Lakes & Waterways Advisory Board Regular Meeting

Approval Shoreline Permit Applications

Shoreline Alteration Permit Staff Report (Boathouse & Dock)

Application #: 21-01 **WATERBODY:** Lake Maitland **Date:** January 2021

HENDERSON PLAN VIEW 115 PALMER AVENUE WINTER PARK, FL 32789

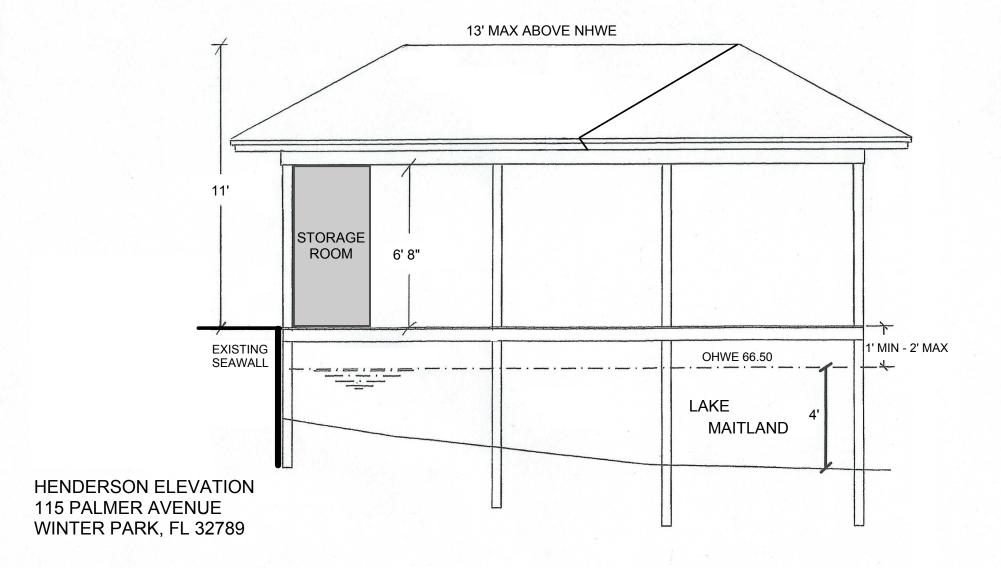
Dock Parameter	Proposed	Allowed	Variance Required?
Total Area (ft²)	590	600 max no	
Length from OHW (ft)	30′	30′	no
Height of Roof (ft above deck)	11'	11 max.	no
Height of Deck (ft above OHW)	1.5′	2 max.	no
Enclosures?	44 sf	80 ft ² max (no plumbing/water allowed)	no
Side Yard Setback(s) (ft)	15'	10 min*	no
Meets Vegetation Criteria?	No	50% may be cleared	n/a

Approval.
